TECHNICAL SERVICE BULLETIN

Shift Knob Rotates Without Brake Pedal Depressed, Transmission Remains In Park (P)

22-2343
19 September 2022

Figure 1

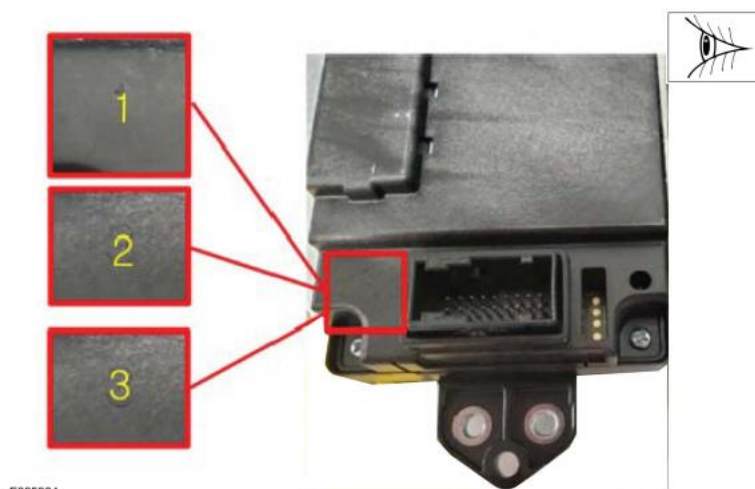
2. Inspect the GSM at the location identified in Figure 1.

(1). If the GSM is marked with numbers 1, 2, or 3, proceed to Step 4.

(2). If the GSM is marked with number 4 or blank, re-install GSM and proceed to Step 3.

3. Reprogram the GSM using the latest software level of the Ford Diagnostic and Repair System (FDRS). Repair is complete.

4. Replace the GSM. Follow the WSM Section 307-05.
